# OBJECTIONS to Planning Application 2020/0927/P: 31 Willoughby Road NW3 1RT

24 April 2020  
Glen Robinson  
39 Willow Road  
Hampstead  
NW3 1TN

This document registers my personal concerns and objections to the submitted planning application for proposed basement works to 31 Willoughby Road, Hampstead NW3 1RT

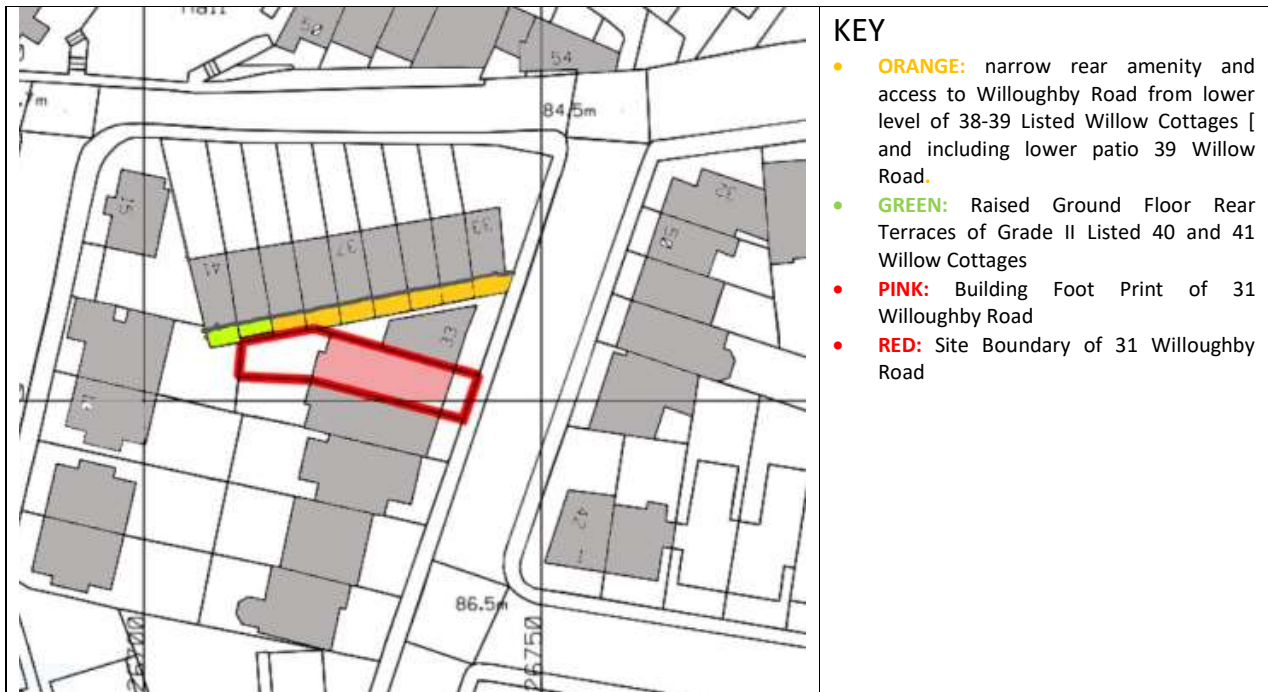
- e) **Harm to the significance of heritage assets**- The planning application disregards the significance of the contiguous registered heritage assets known as Willow Cottages that includes the listed lower rear retaining wall. The very close proximities of the new construction to the registered heritage assets by way of the new excessively deep excavations, formation of safe shoring to allow construction of new RC retaining walls, the extreme vibrations from piling all will cause unacceptable levels of damage to these registered heritage assets. There is a duty of care to provide and guarantee safe protection of the contiguous listed heritage assets which the proposal does not give. See Figure Plan, showing Willow Cottages rear amenity and access plus Photographs inclusive at the rear of this document.

**Policy A5 – Basements: Demolition and construction and impact on amenity:** Item 6.125 states that *‘the demolition and construction phases can have an impact on amenity, and this is a particular issue for basements’*. Given the proposal’s extremely close proximity to 29 and 31 Willoughby Road and the rear long boundary of lower structures and spaces of abutting heritage assets Willow Cottages with the retaining wall which forms safe play and amenity space for children at 37 and 35 Willow Cottages and small patio and terrace spaces to 39-40-41 Willow Cottages, the demolition, shoring and construction works [e.g. piling] associated with the application will impact greatly in diminishing amenity of neighbouring properties – over and above the damage caused by the works themselves. See Photographs and Plan diagram at the rear of this document.
